February 22, 1994  
LD-94-012

Docket No. 52-002

Subject: System 80+™ Information for Issue Closure

The attachments to this letter provide material to close follow-on questions to DSER responses. Attachment 1 provides minor revisions to Section 1.4 of CESSAR-DC in response to a comment from Mr. T. Boyce.

Figure 2B-5

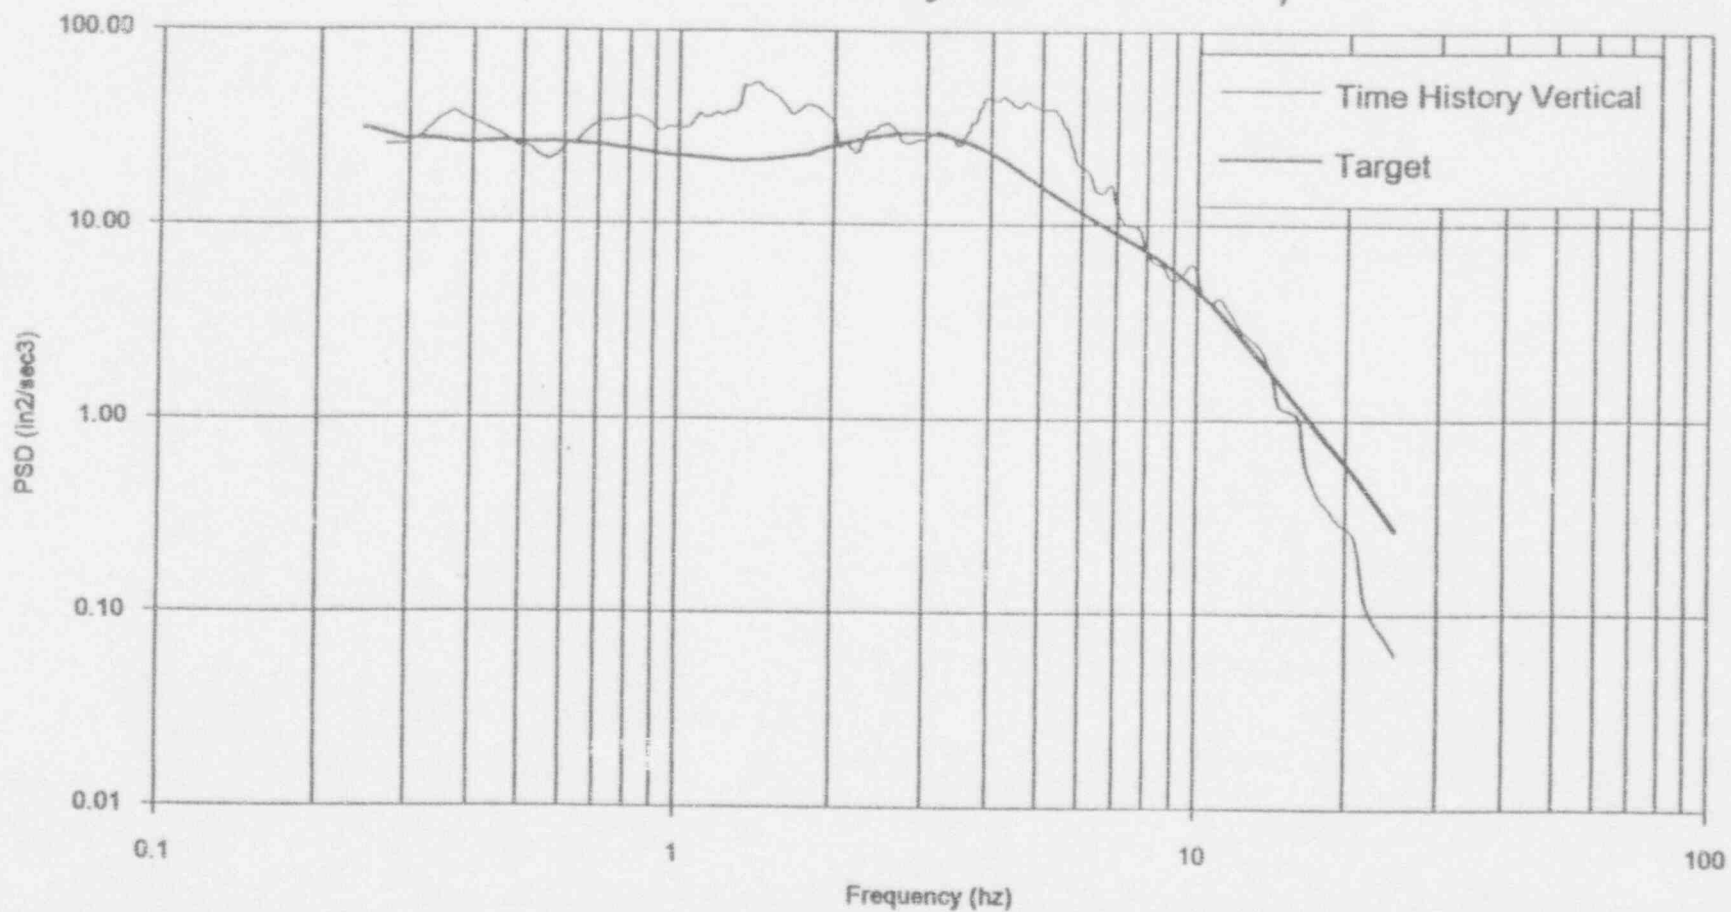
Average Power Spectral Density,  
CMS1, ~~Motion~~ Vertical Component

Figure 2B-9

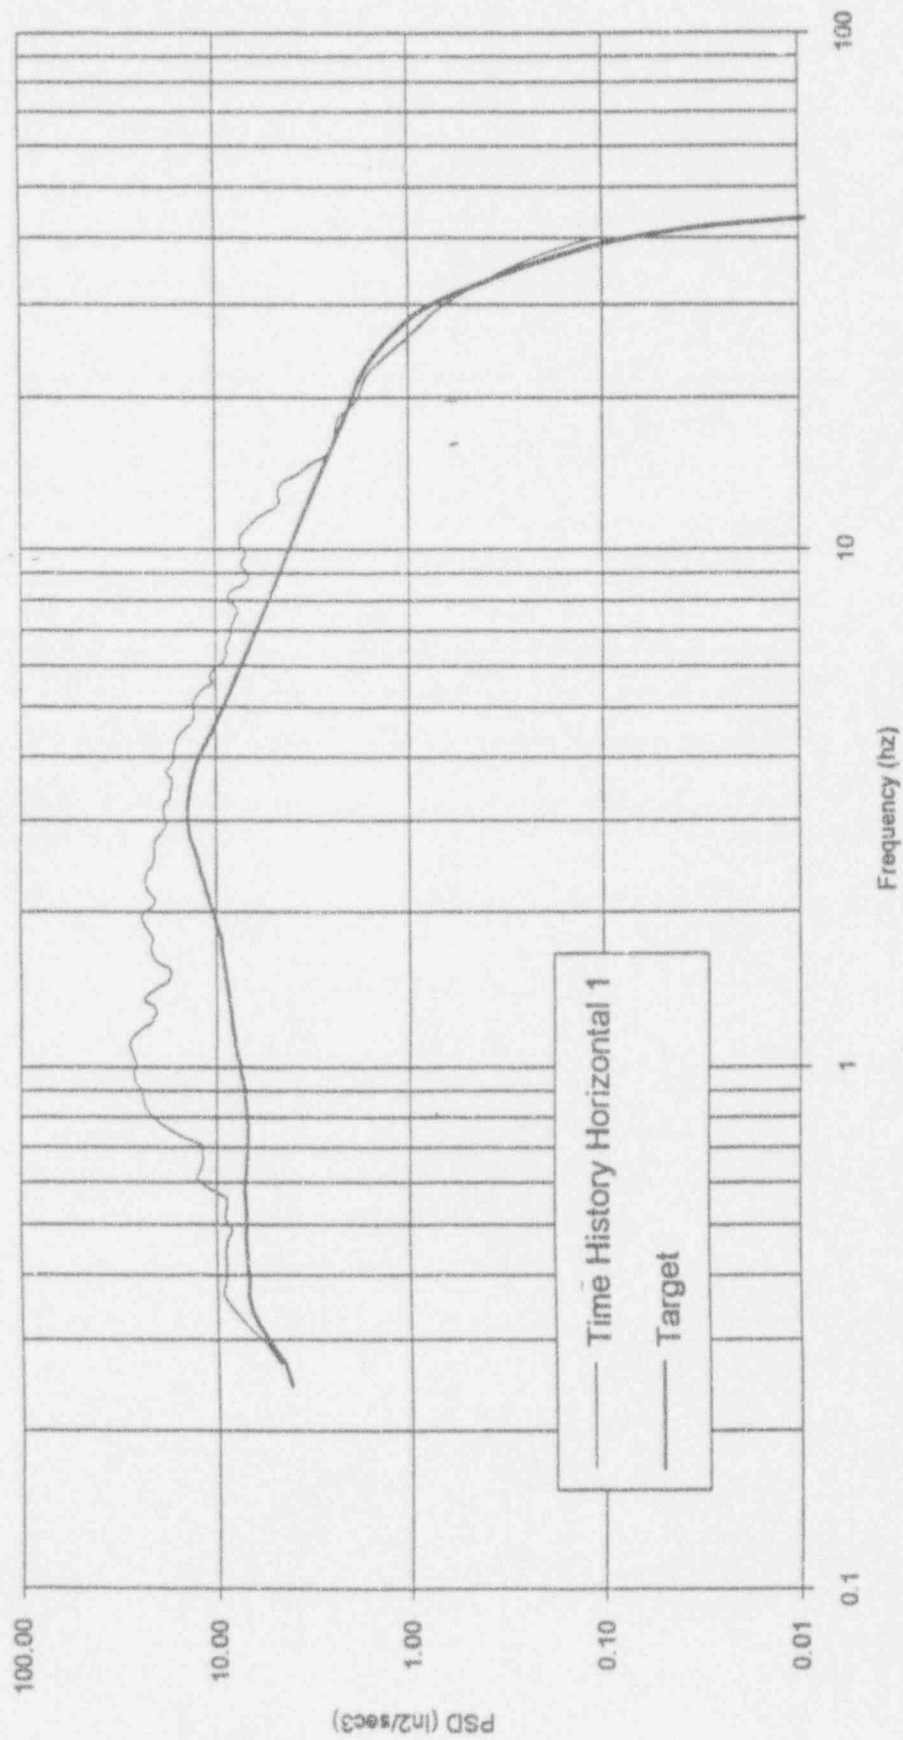
Average Power Spectral Density,  
CMS2, ~~Horizontal~~ Component #1

Figure 2B-13

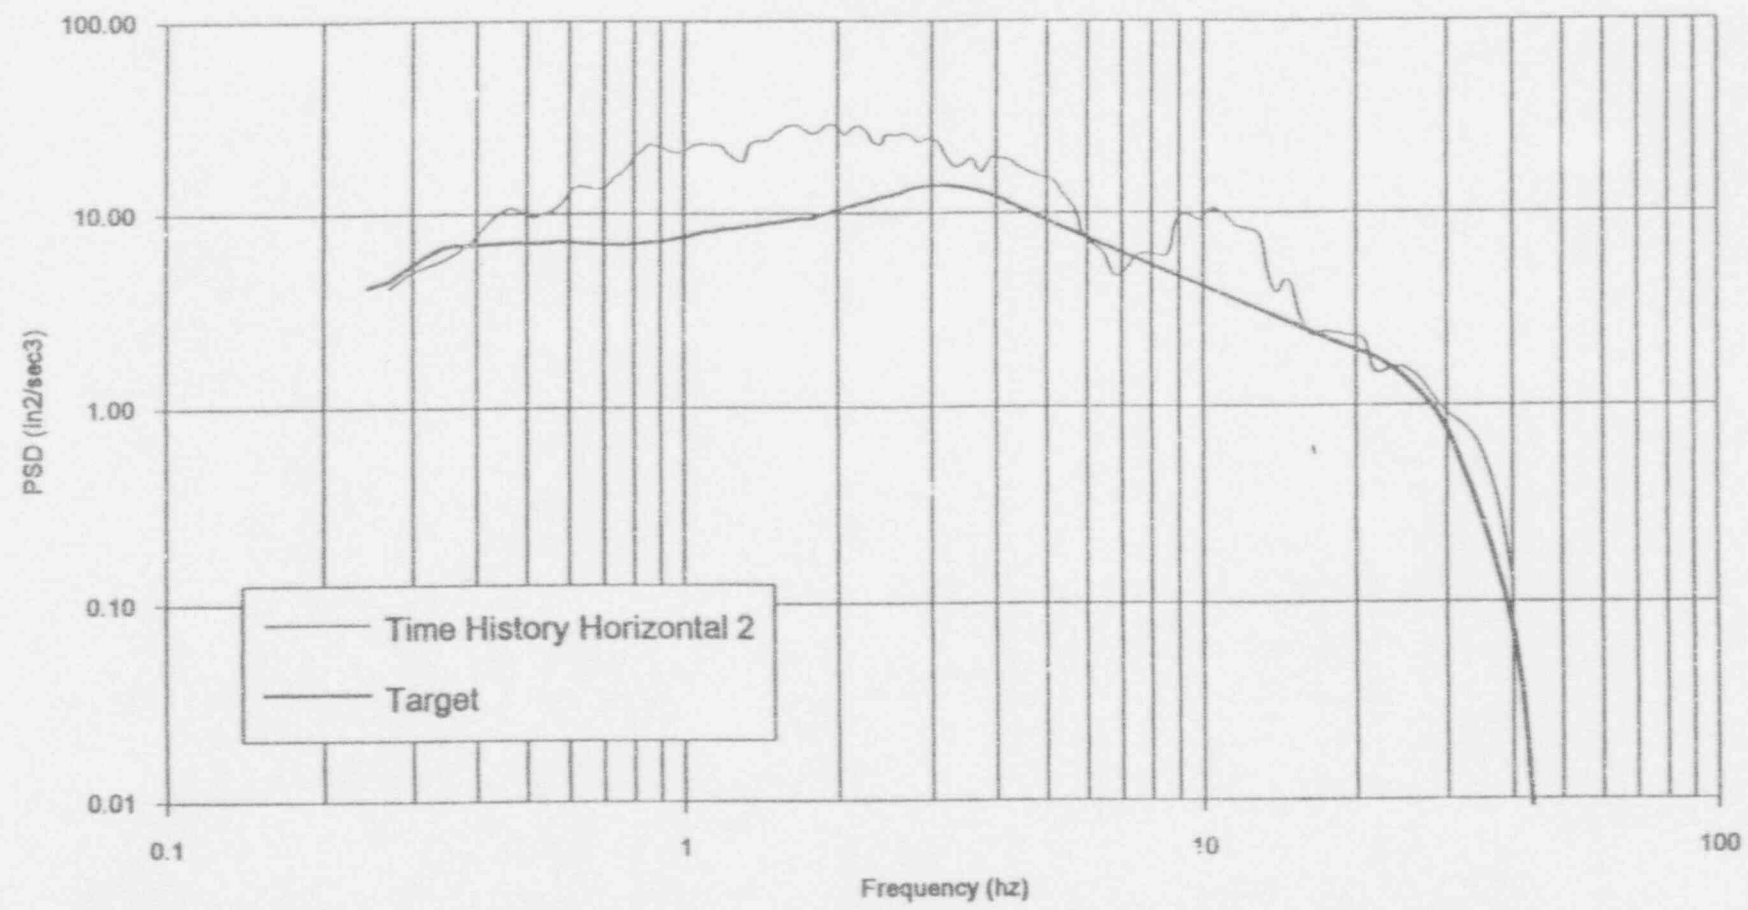
Average Power Spectral Density,  
CMS2, ~~Motion~~ Component H2

Figure 2B-17

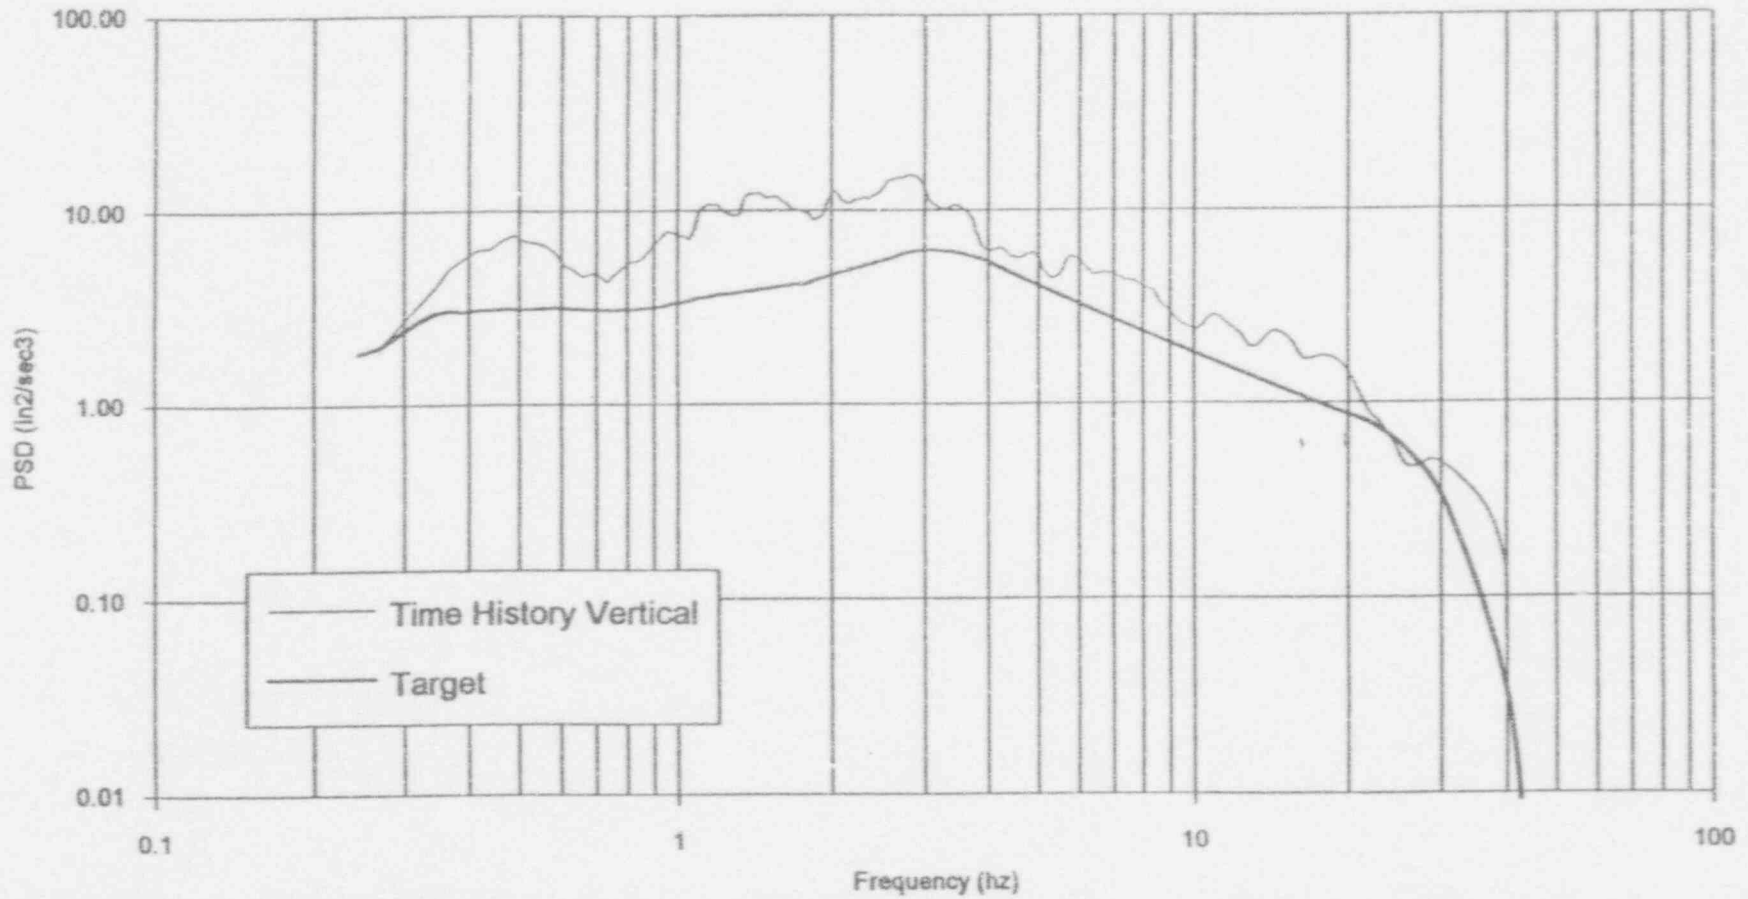
Average Power Spectral Density,  
CMS2, ~~Motion~~ Vertical Component

Figure 2B-21

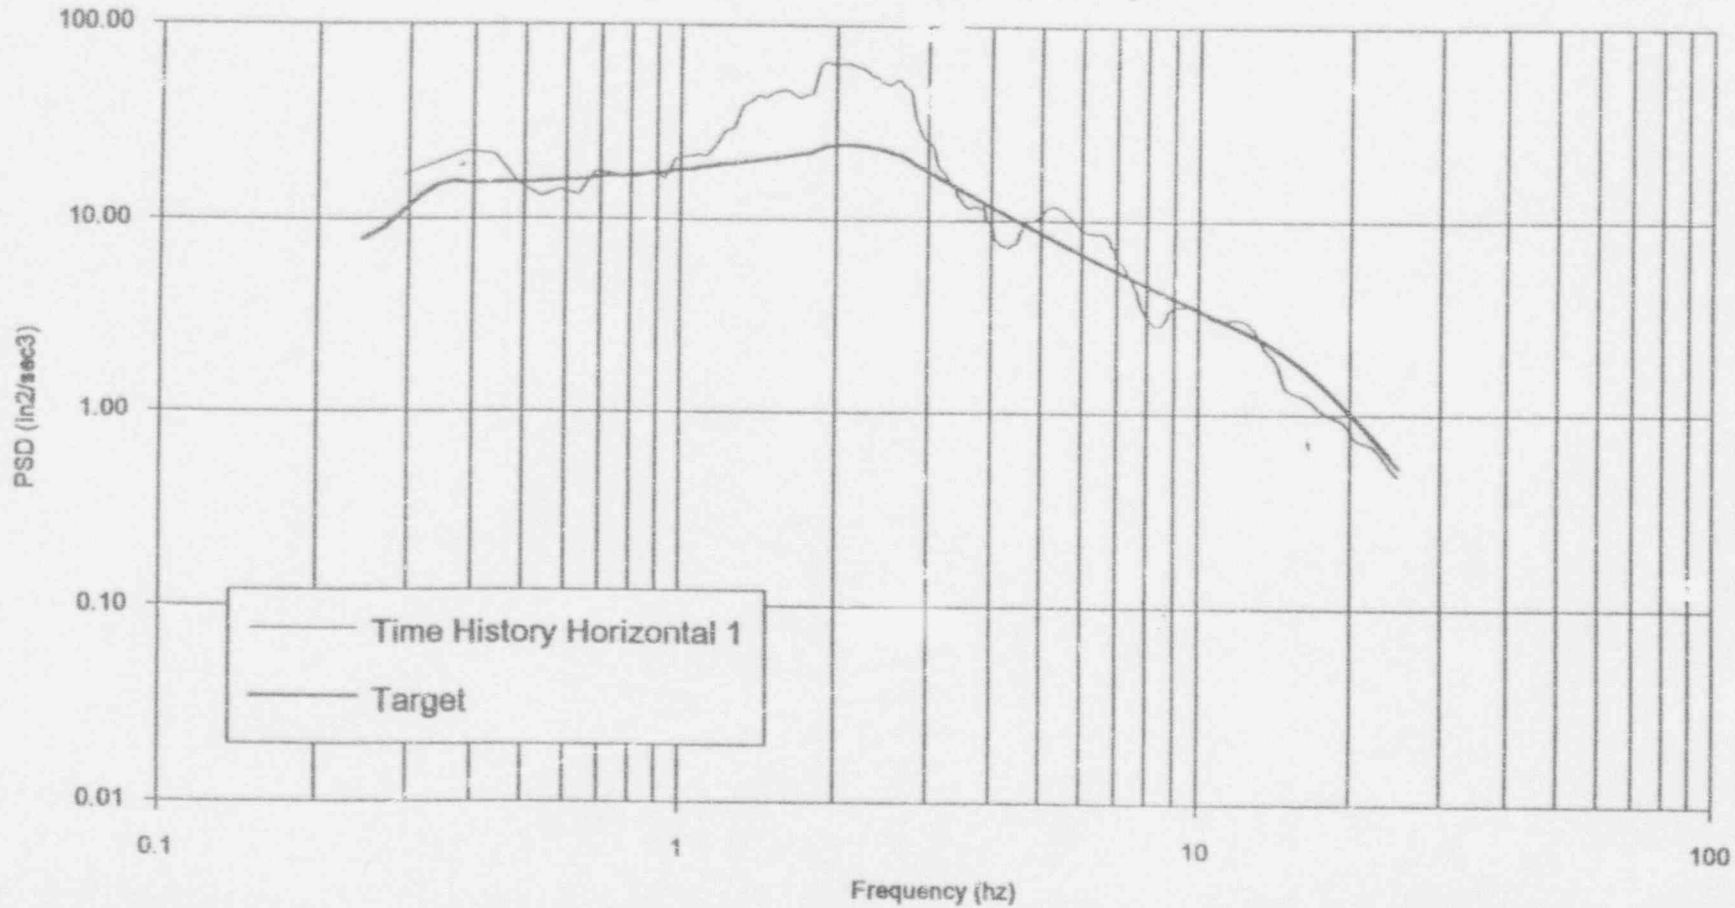
Average Power Spectral Density,  
CMS3, ~~Motion~~ Component H1

Figure 2B-23

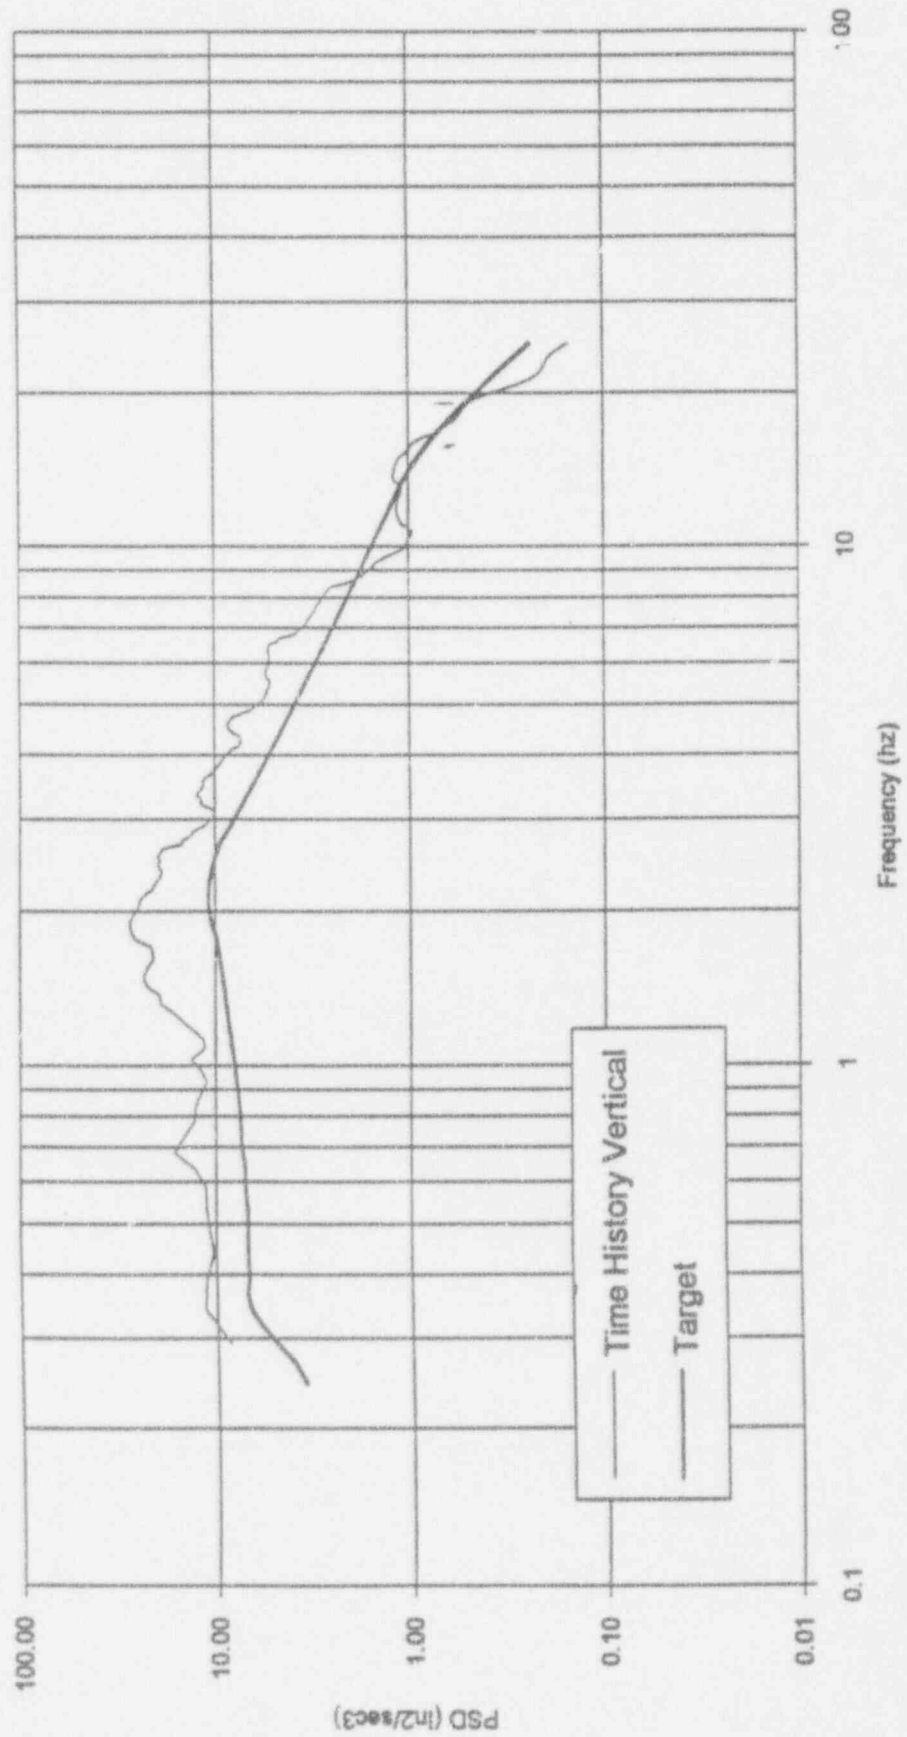
Average Power Spectral Density,  
CMS3, ~~Motion~~ Vertical Component

Figure 3.7c-10

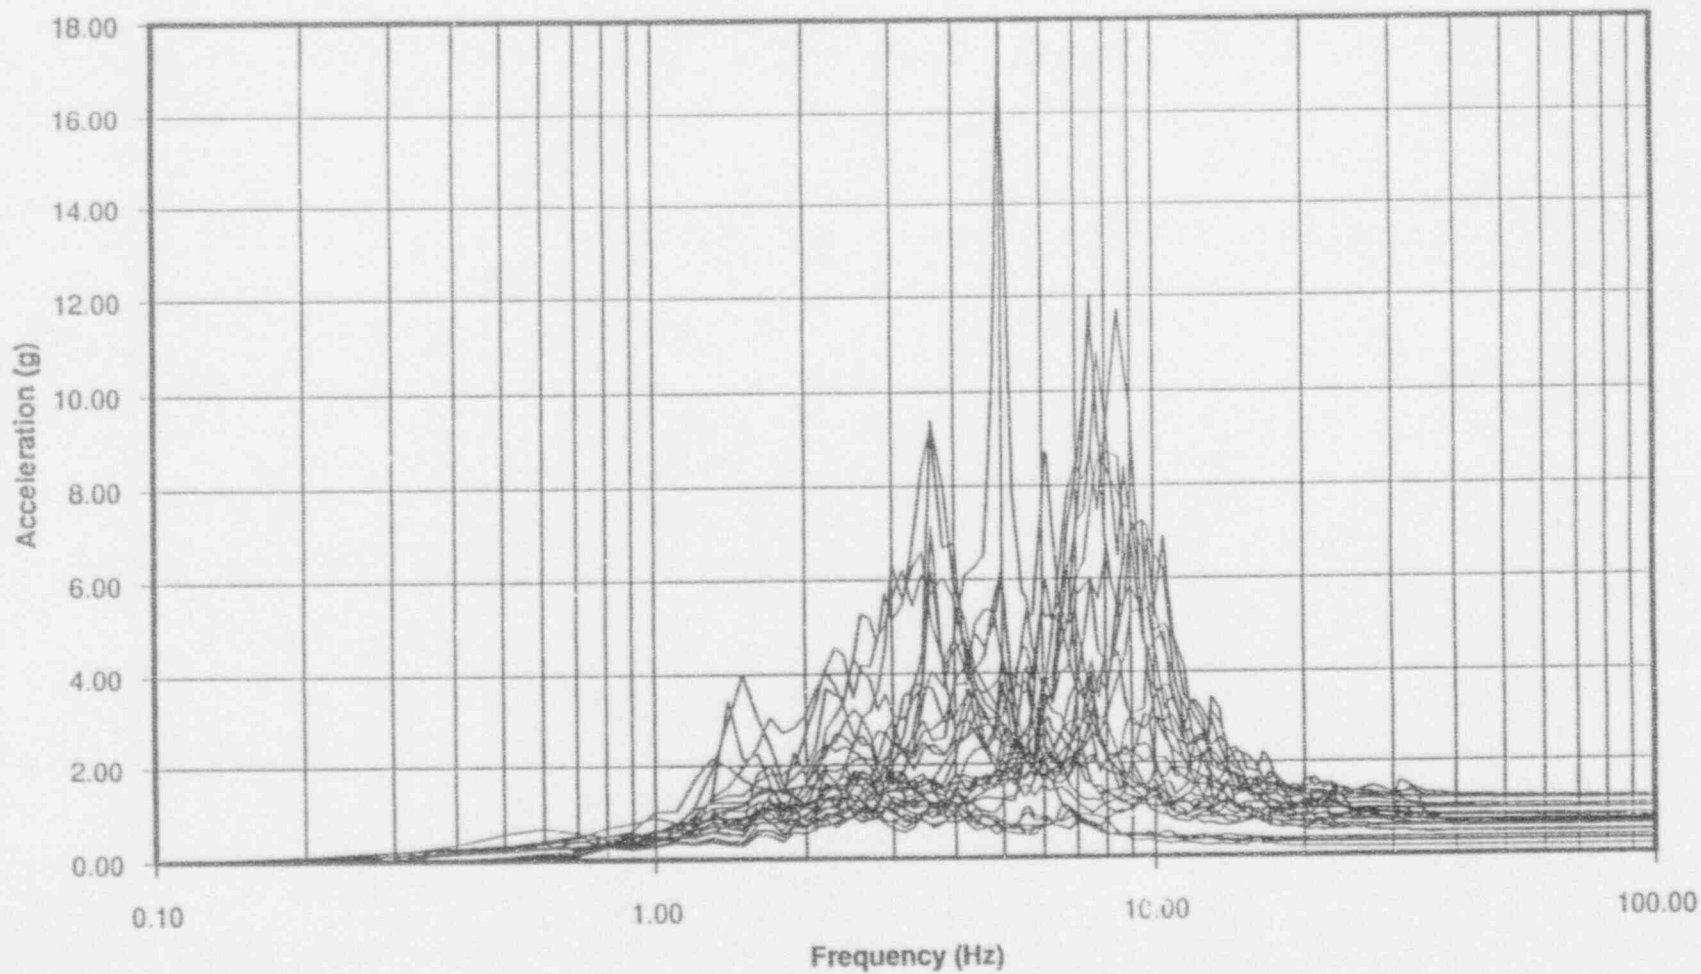
~~CE System 80~~ Response Spectra at Elev. 111.75' of CCW, All Soil Cases, All Motions,  
Horizontal Model, H2 Motion (N-S), 2% Damping
